Ref: 2023/(PSIL)BELSKRD2/PSIL/PlanD/RtoC_02

Amendment of Plan to Rezone from “Residential (Group D)” (“R(D)”), “Residential (Group E)” (“R(E)”) and an area shown as ‘Road’ to “Residential (Group C)3) (“R(C)3”) on the Approved Ho Chung Outline Zoning Plan No. S/SK-HC/11 Various Lots in Demarcation District 210 and Demarcation District 244 and Adjoining Government land Ho Chung, Sai Kung, New Territories, Hong Kong

Responses to Comments from Government Departments via Planning Department’s email on 17.10.2023 on the Planning Application No. Y/SK-HC/6 issued on 31.08.2023 (Comments from the Environmental Protection Department were replied on 30.10.2023)

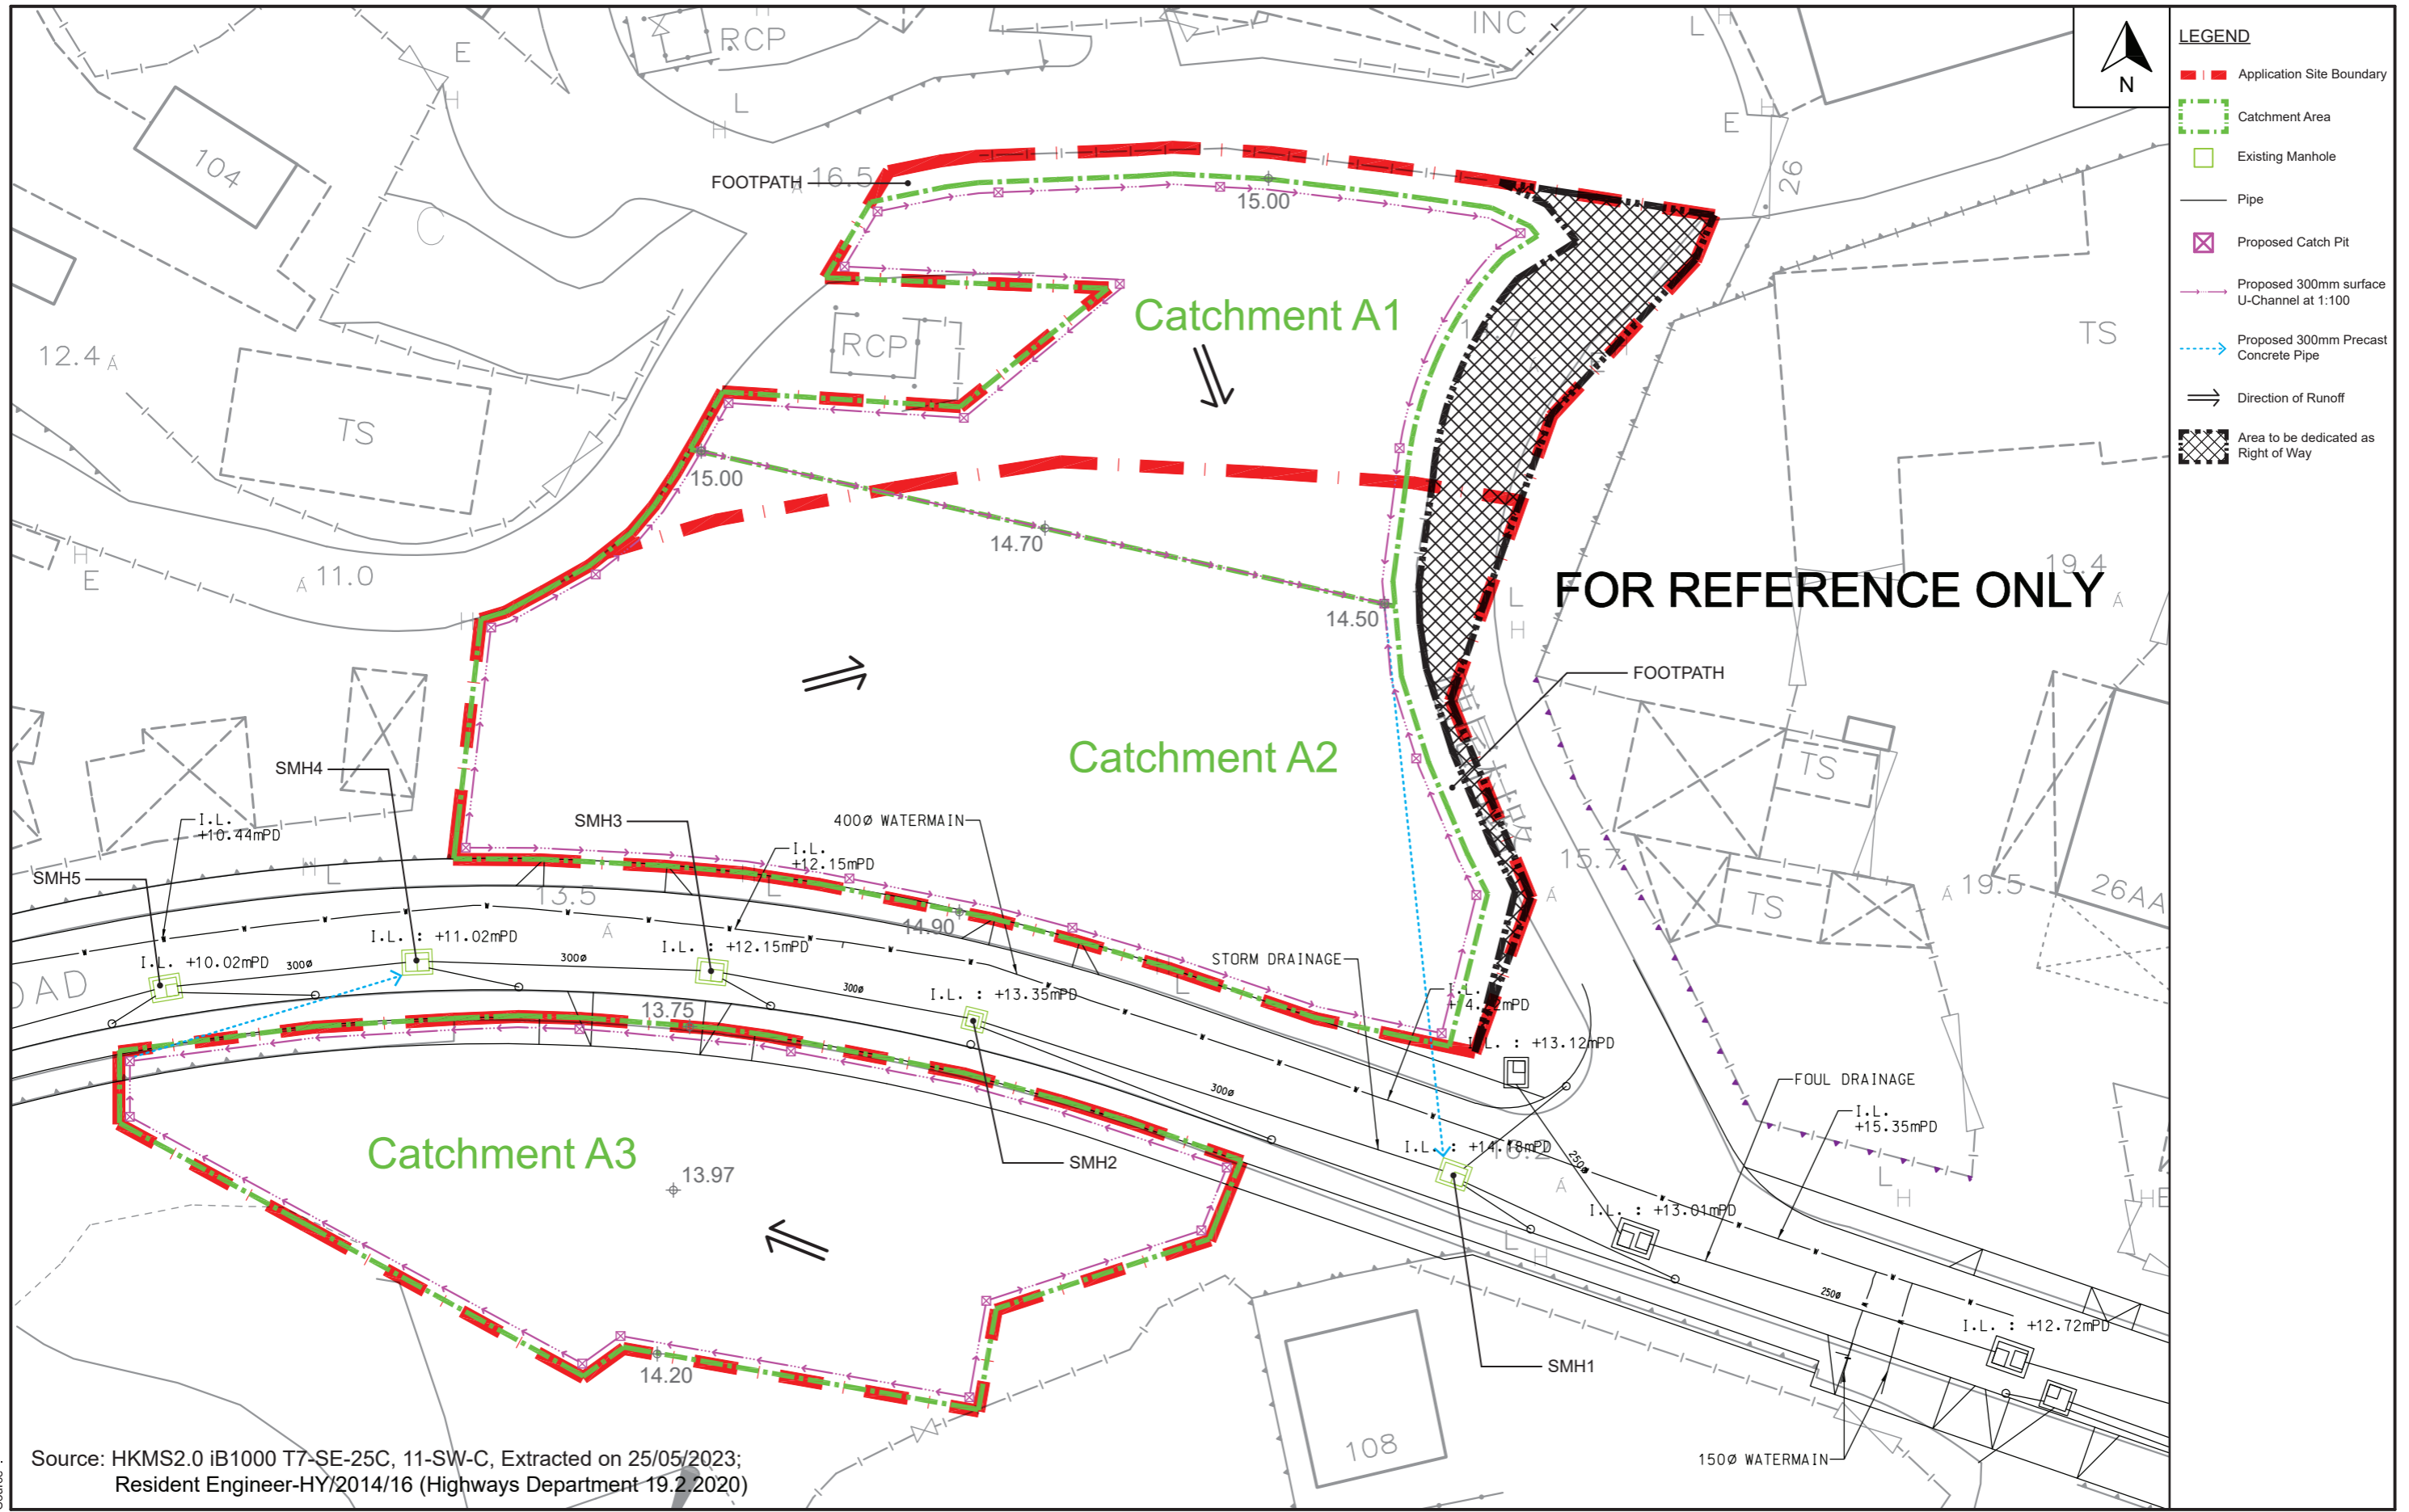
DSD – DIA5	<p><u>Figure 3.2</u></p> <p>Please clarify what is the "Foul Drainage" as shown in the legend.</p> <p>Please be advised that there is no public sewerage system available for connection currently.</p>	<p>It is assumed “Foul Drainage” is equivalent to “Sewerage Drain”. The figure legend has been updated in the SDIA (Ver. B) and enclosed in this RtoC Table as Attachment 3.</p> <p>Noted. And the Proposed Development has its sewerage system.</p>
<p>Comments from the Director of Water Supplies for Water Supplies Department (WSD) via Planning Department’s email on 17.10.2023; Contact Person: Mr. Brandon CHUNG (Tel: 2152 5577)</p>		
<p><u>Comments on Water Supply Appraisal (WSA)</u></p>
